Location
 2724 Waunona Way
 Project Name
 Faust Waterfront Project
 Applicant
 Jim Willmore/Scott Faust

Proposed Use
 Consideration of a Request to
 Remove Trees

Public Hearing Date
 Plan Commission
 08 January 2007

RE: 2724 Waunona Way – Removal of Trees

SCOTT FAUST LOT
Oct 31, 06

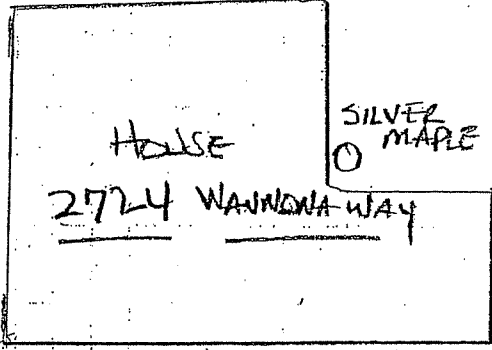
2. Boxelder C has a severe lean and B and D are in decline with dangerous dead tops. Mulberry E has decay at the co-dominant connection and will fail under load.

4. Red oak H has extensive trunk decay and a cracking trunk shell with a lean toward the parking lot. This may be a shared tree with the park. I recommend immediate removal for safety.

6. Red oak M has a cavity and extensive decay at the base of the trunk. Remove this tree for safety. The remaining oaks should be tested for concealed trunk decay prior to construction. Use acoustic stress testing combined with Resistograph micro-drill resistance testing.
7. Prior to construction create a tree protection plan.
